# **FIRE SAFETY INSPECTION REPORT**

**RADISSON GARMENTS LIMITED**

**ACCORD ID: 12126**

April 20, 2015

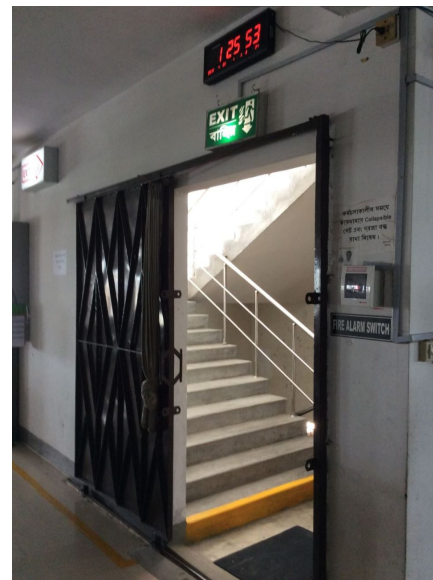
F-2	Fire Rated Construction	Unsealed electrical shafts are located in the fire-rated floor/ceiling assemblies on fourth and fifth floors.	Provide a minimum 2-hr fire-rated shaft to separate the utility risers from each floor level and seal all penetrations in floor/ceiling assemblies to maintain the fire separation.	Within 3 months
-----	-------------------------	---	---	-----------------

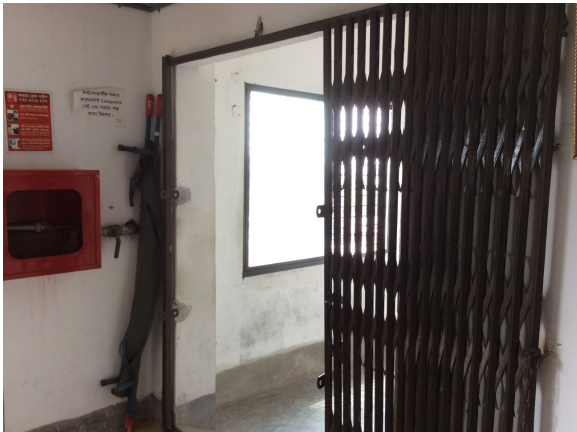
F-3	Fire Rated Construction	The exit stairs are not separated from work areas and other spaces on each floor by fire-rated construction.
-----	-------------------------	--

Provide minimum 1.5-hr fire rated doors for buildings that are 4 or more stories. Seal all unprotected openings to separate the exit stairs from work areas and other building spaces on all floor levels. Ensure that the fire doors are self-closing and positive latching and that they are provided with fire exit (panic) hardware where serving production floors.

If fire doors are required to be held open for functional reasons, provide automatic-closing devices tied to the fire alarm system.

Once fire doors are installed, every door in a stair enclosure serving more than 5 stories shall be provided with re-entry unless it meets ACCORD standard 6.8.3.1.

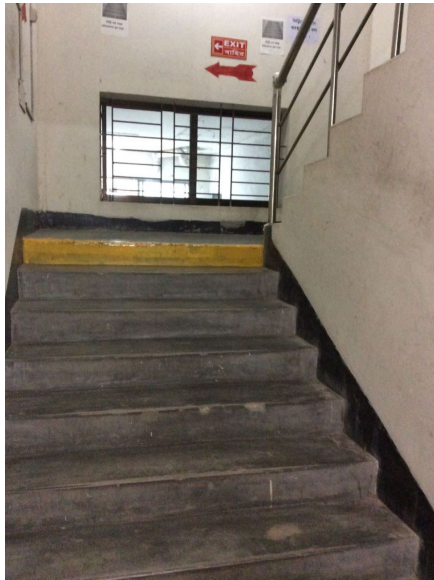
F-4	Fire Rated Construction	Unsealed penetrations and openings are located in south east exit stair enclosures.	Seal all penetrations and openings in exit stair enclosure walls to maintain the fire separation.	Within 3 months
-----	-------------------------	---	---	-----------------

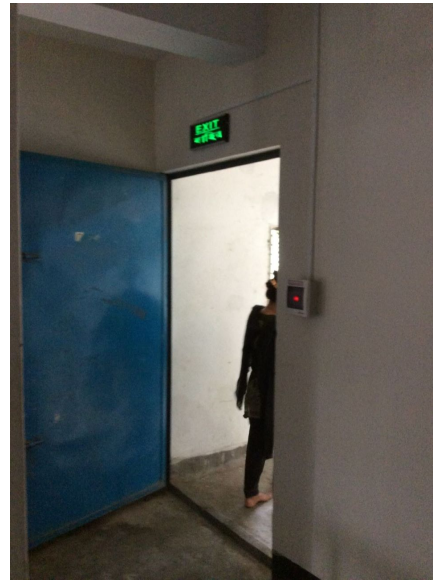
F-6	Fire Rated Construction	Storage rooms discharge directly into all exit stair enclosures. Transformer room discharges directly into south east exit stair enclosure.	<p>Openings from exit enclosure to storage and transformer rooms shall be provided with a vestibule with fire rated construction and openings.</p> <p>Provide a 1.5 hr. fire rated door on the exit stair side and a 1-hr. fire rated door on the storage and transformer room side. Ensure that the fire rating of the vestibule construction matches that of the exit stair enclosure.</p>	Within 3 months
-----	-------------------------	---	--	-----------------

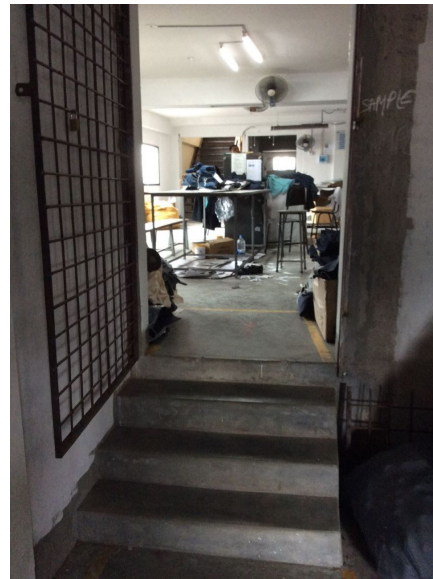
F-9	Fire Rated Construction	Rooms used for combustible storage are not separated by fire-rated construction on ground and first floors.	Provide dedicated storage rooms separated by minimum 1-hr fire-rated construction.  Where separate storage rooms are not feasible, provide defined storage areas and limit the storage arrangement as follows: - Maximum height of 2.45m (8ft.) and maximum area of 23m <sup>2</sup> (250 ft <sup>2</sup> ) - If sprinkler protected: maximum height of 3.66m (12ft.) and maximum area of 93m <sup>2</sup> (305ft <sup>2</sup> )  Separate areas of unenclosed combustible storage by a minimum clear distance of 3m (10ft.).	Within 3 months
-----	-------------------------	---	---	-----------------

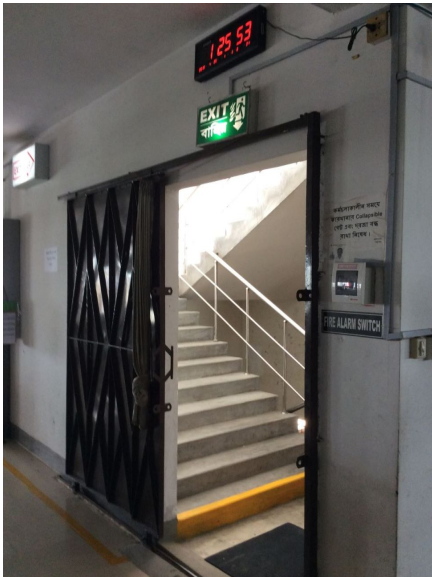
F-11	Egress	Building did not have stair designation signs at exit stairs. Building did not have occupant load signs on factory floors.	Provide stair designation signs and occupant load signs at required locations.	Immediately
------	--------	--	--	-------------

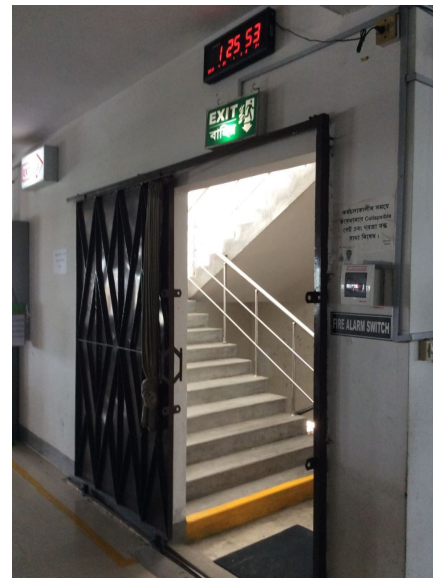
F-14	Egress	Storage was located in the south west, south east and south exit stairs.	Remove all storage from exit stairs and egress paths.	Immediately
------	--------	--	---	-------------

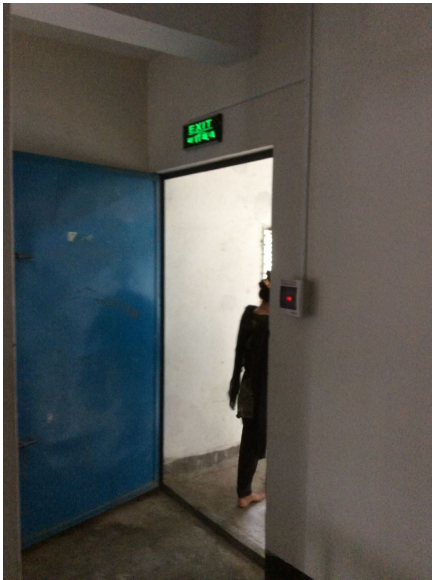
The width of egress aisles is less than 36-in. on all floors.

Provide minimum aisle widths of 36-in.

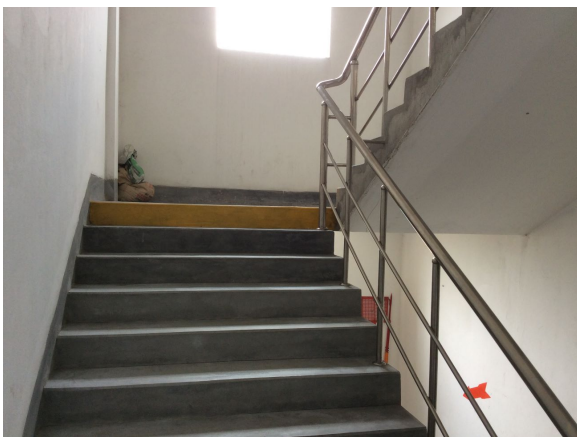
Handrails are not provided on both sides of all the exit stairs.

Provide handrails on both sides of the exit stairs. New handrails shall have a minimum height of 865 mm (34 in.) and a maximum height of 965 mm (38 in.) as measured from the leading edge of the tread. Intermediate handrails shall be provided when the stair width exceeds 2.2 m (87 in.)

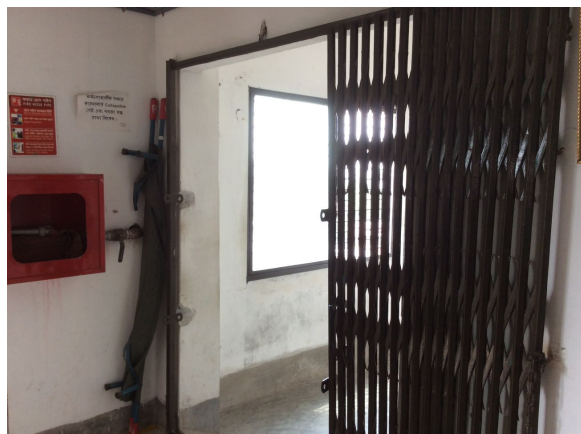
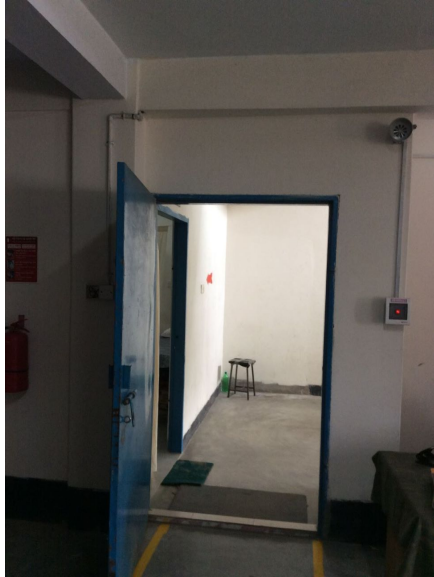
F-29	Egress Lighting	Exit signage was not provided at floor exits.	Provide exit signs above all building exits to the exterior, all doors to the exit stairs and along all paths of travel where a change of direction is not obvious.	Within 1 month
------	-----------------	---	---	----------------
